01/08/24

Subject: Change to USCAR-30, Rev 1 (Revision Letter # 1)

Figure 5.1.9.4: Intermittency Measurement

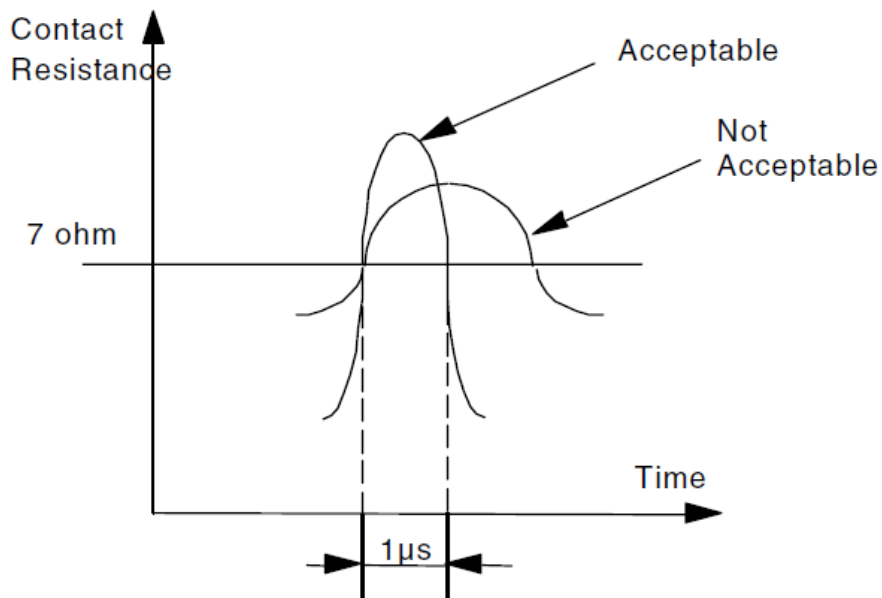
Section 5.1.9.4 of USCAR-30 has a typing error that needs to be corrected: an incorrect requirement of 70 Ohms but 7 ohms is the actual requirement.

The following correction is made to change the value of 70 to 7.

Where continuity monitoring is required during any conditioning procedure, there must be no loss of electrical continuity, for more than 1 microsecond. If one or more terminal pairs are monitored, rather than the series resistor, there must be no instance in which the resistance of any terminal pair exceeds ~~70~~ 7 Ω for more than 1 microsecond. Figure 5.1.9.4 illustrates the acceptance criteria graphically.
